**DATE:** 03.20.2019  
**TO:** ProTrak  
**FROM:** Mitesh Baxi  
Traffic Engineering

■ **INTEGRITY BUILDERS [TRC Plan Review]**

↻ Initial Review Note ↻

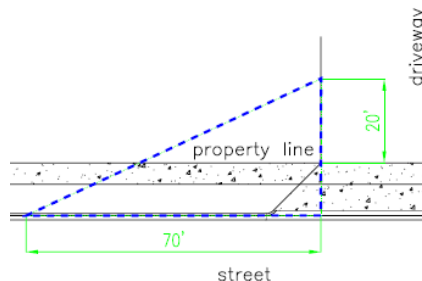
1. The minimum two-lane driveway width is 23'. [7-9 CofW Tech Stds]
2. Dimension the flares for the driveway.
3. Provide curbing detail SD 3-11 on the plan. [Sec. 18-529(b)(2) CofW LDC]
4. Show and apply the City's 20'x70' sight distance triangle at driveway as per below image [Sec.18-529(c)(3) CofW LDC] [Sec. 18-812 CofW LDC].
